## Purpose of Change

**Re: Application for a Permissive Change Filing with FCC ID: EW780-9982-01**

The purpose of this document is to describe all the changes that are made on **Parent Unit** to the new designed family models **DM1211 PU** from the original model **DM202 PU** in order to meet the requirements.

DM202 PU RF layout (35-200347-003-100)    DM1211 PU RF layout (35-200992-000-100)

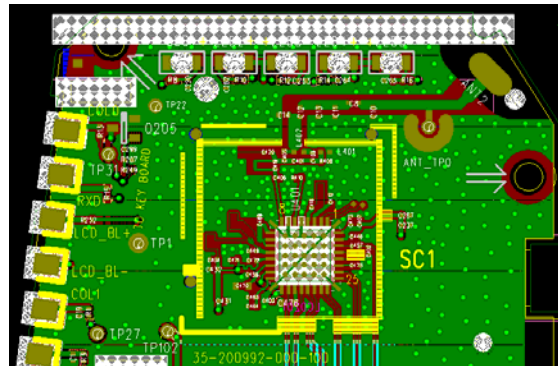
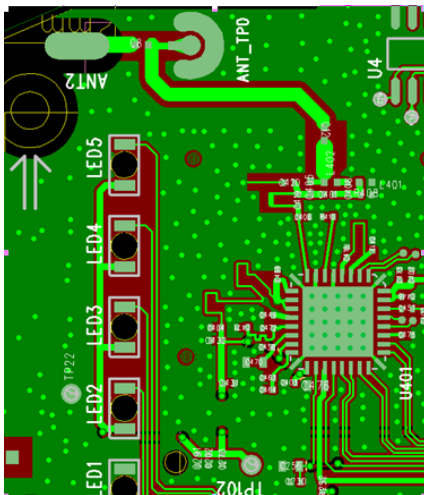
**Changes of Parent Unit from reference model to the new designed model:**

- **Non-RF circuit and its layout**
- **RF matching circuit and its layout**
- **Antenna size and location**
- **External appearance**
- **Coslight (LH075-3AH45C2B ) is cancelled**

- RF IC/circuit/layout
- Antenna type and gain
- No change in radio parameters has occurred.
- RF conducted and radiated emission level is similar.
